Failure Analysis: 12,780 RPM Ethane Refrigeration Compressor Major Reliability-Safety Improvement

By Abdulrahman Alkhowaiter & Minwer Juhani

Subject: Ethane Liquefaction compressor K-141 Bearings & Eliminating Slow Roll Mechanism

Picture Above: Drive Mechanism Removed at NDE Bearing Housing, Blinded with Flange

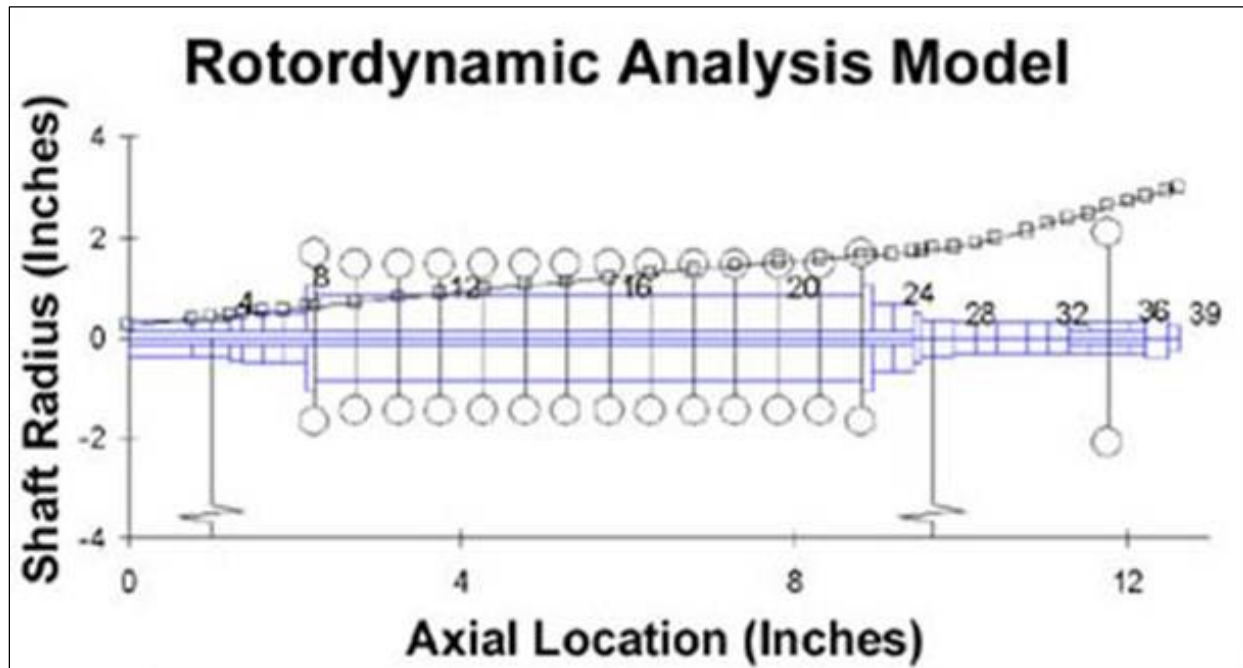
Modification: Compressor Slow Roll Motor-Gear Removed from NDE Bearing Housing: This machine has always been reported difficult and unsafe to operate by field operators. The innovative idea of eliminating the low temperature Ethane compressor slow rolling motor mechanism has succeeded well, and field tests have proven it can be operated normally without slow rolling. Decision was based upon studying the compressor temperature differentials, analyzing the rotor stiffness, and making field deflection measurements and actual testing.

The K-141 compressor was started at normal conditions with minimal impact on radial vibration not exceeding 0.10 to 0.20 mills above past operation according to Vibration data. The outboard end mechanism has been removed from the machine permanently, and the compressor reliability and operation procedures will be improved greatly. The compressor is now safer and more reliable; the original OEM intent to apply the mechanism was good, but it is not required.
